**PORT OF KENNEWICK – 415 N. ROOSEVELT A&B
FAÇADE IMPROVEMENTS**

ADDENDUM NO. 1

August 29, 2024

415 N. ROOSEVELT A&B FAÇADE IMPROVEMENTS

PRG. NO. **A201**
COLOR
 SHEET NO. **9054**

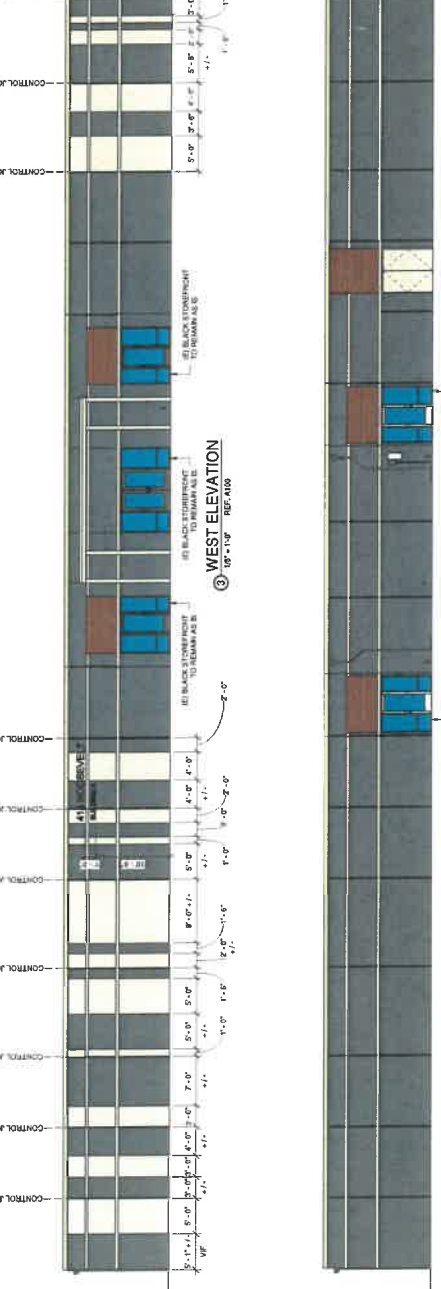
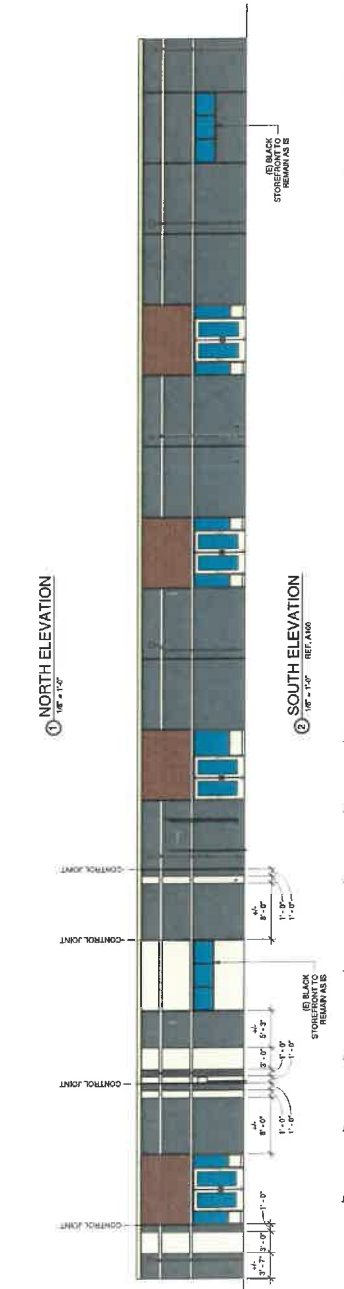
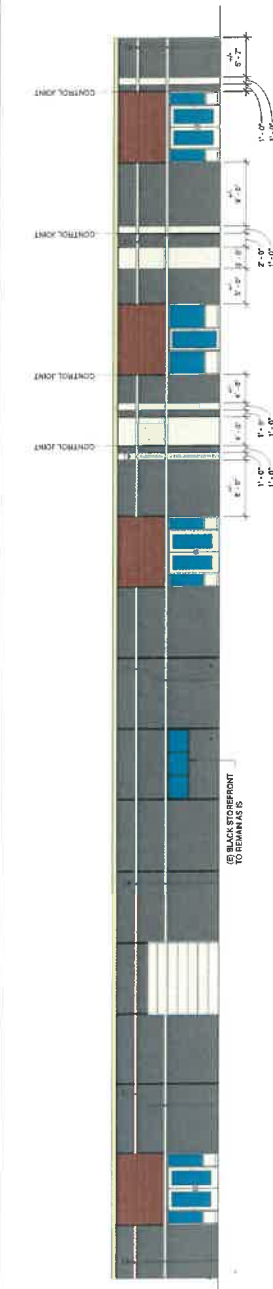
a. A201 – Bldg. A Ext. Elevations per Kennewick Fire Department requirement.

i. New **18”** steel numbers and letters.
